California Department of Fish and Game
North Central Coast Study Region
Feasibility Evaluation of Draft MPA Proposals
February 11, 2008

This evaluation was completed by the California Department of Fish and Game for the MLPA North Central Coast Regional Stakeholder Group (NCCRSG) to provide detailed feedback on the feasibility for the suite of marine protected area (MPA) proposals received. The feasibility guidelines used were outlined in the document titled, "*Statement of feasibility criteria for use in analyzing siting alternatives during the second phase of the Marine Life Protection Act Initiative*" (CDFG Memo; June 11, 2007). A second memo, "*Department of Fish and Game update of feasibility criteria for use in analyzing siting alternatives during the second phase of the Marine Life Protection Act*" (CDFG Memo; February 11, 2008), was also created to clarify feasibility issues that have arose during the North Central Coast study region process, and was also used to evaluate the current MPA proposals.

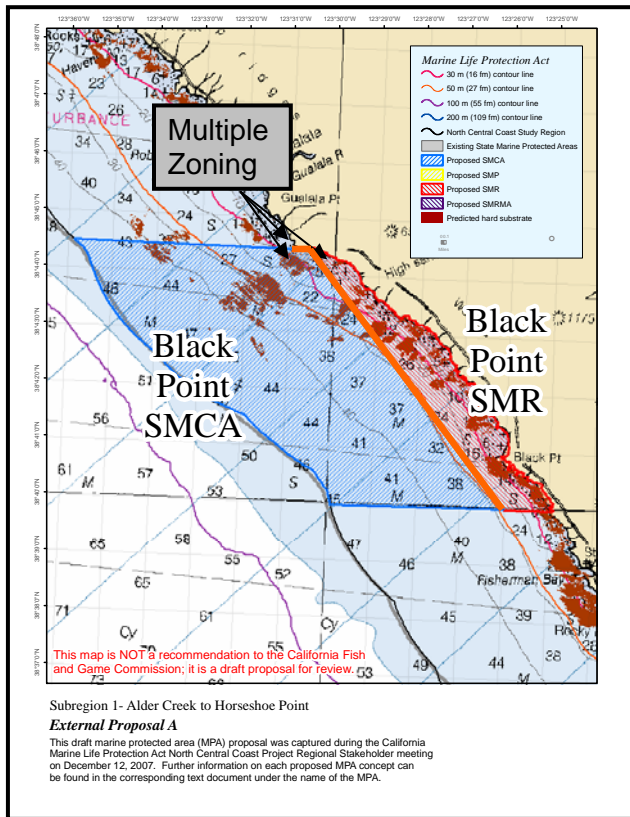
Arena Rock SMCA and SMR: Floating corners were created at the north- western, north- eastern and south- western corner of the SMR. Offshore corners should be located at whole minute lines of latitude and longitude (see: general suggestions for improving the feasibility of the draft proposals; bullet #2).

- Floating corners are difficult to enforce.

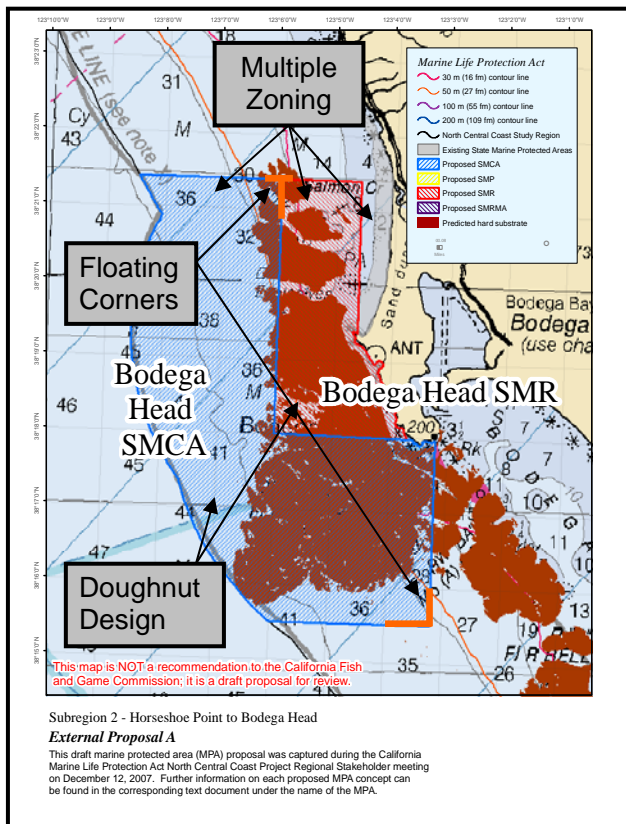
Black Point SMR and SMCA: Diagonal lines may be feasible when they follow the angle of the coastline and are anchored at whole minute points of latitude and longitude. The western boundary for Black Point SMR is an un anchored diagonal line that does not follow the angle of the coastline. Multiple zoning is created with regulatory changes occurring over a small area in the north- eastern corner of the MPA cluster.

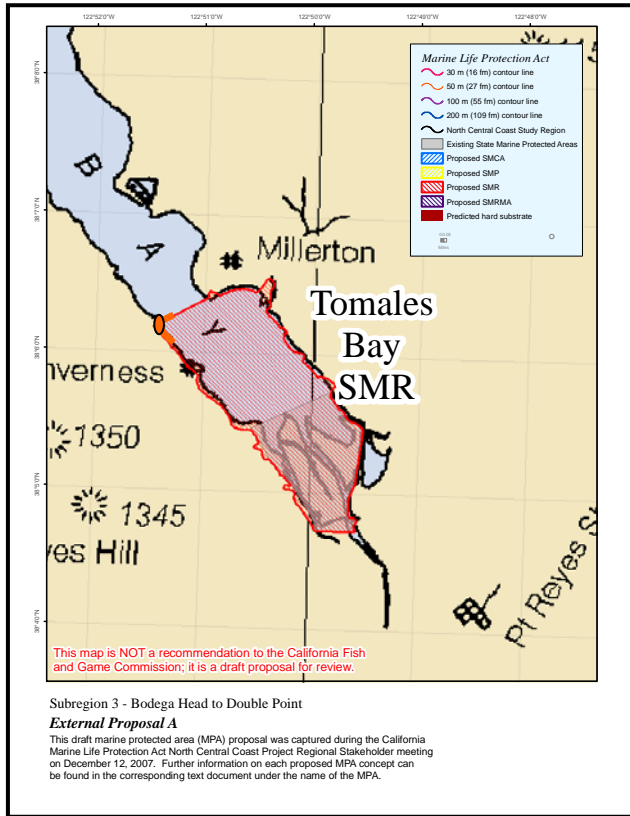
Bodega Head SMR and SMCA: Doughnut design with Bodega Head SMR surrounded on two sides by Bodega Head SMCA. Multiple zoning over a small area is created in the northern portion of this cluster with Bodega Head SMCA, Bodega Head SMR and nearshore non-MPA designated waters. Multiple designations in a small area are difficult to enforce and create confusion among user groups. Floating corners were created in the north-western corner of Bodega Head SMR and the south-western corner of Bodega Head SMCA. Offshore corners should be located at whole minute lines of latitude and longitude (see: general suggestions for improving the feasibility of the draft proposals; bullet #2).

- Enforceability and public understanding would be enhanced by simplifying this

cluster.

Pt. Reyes SMR and SMCA: A floating corner was created in the north-western corner of Point Reyes SMR. Offshore corners should be located at whole minute lines of latitude and longitude (see: general suggestions for improving the feasibility of the draft proposals; bullet #2).

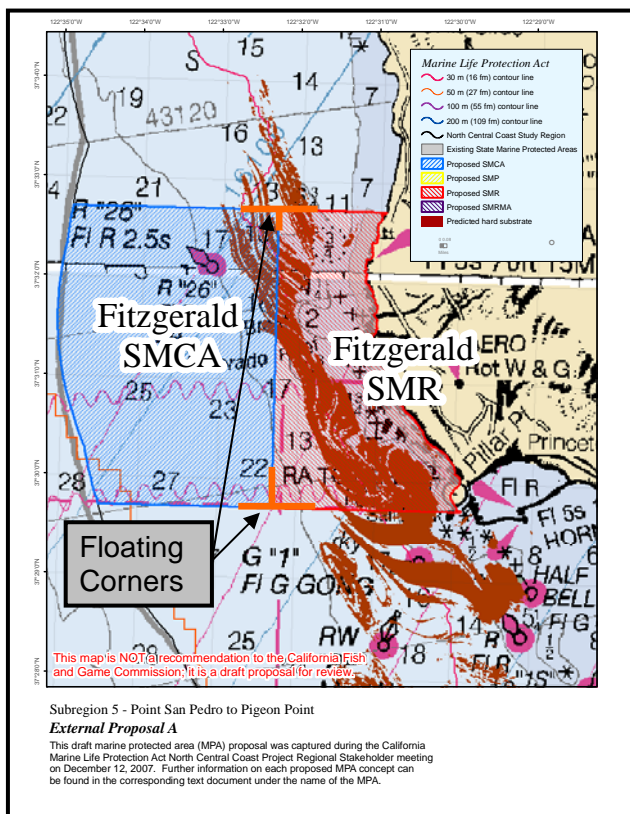
- Floating corners are difficult to enforce.
- This area is remote and a long response time is expected.

Fitzgerald SMR and SMCA: Floating corners were created in the north-western and south-western corners of Fitzgerald SMR. Offshore corners should be located at whole minute lines of latitude and longitude (see: general suggestions for improving the feasibility of the draft proposals; bullet #2).

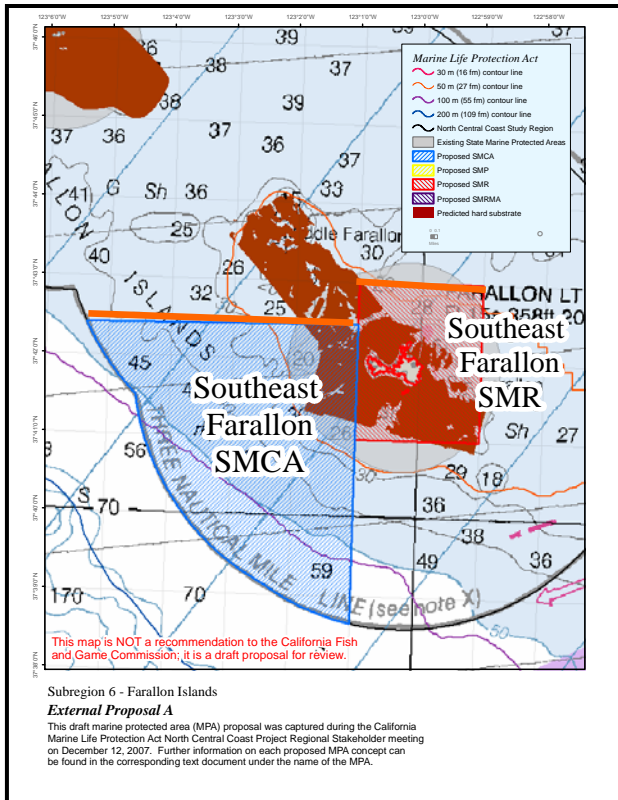
- Floating corners are difficult to enforce.
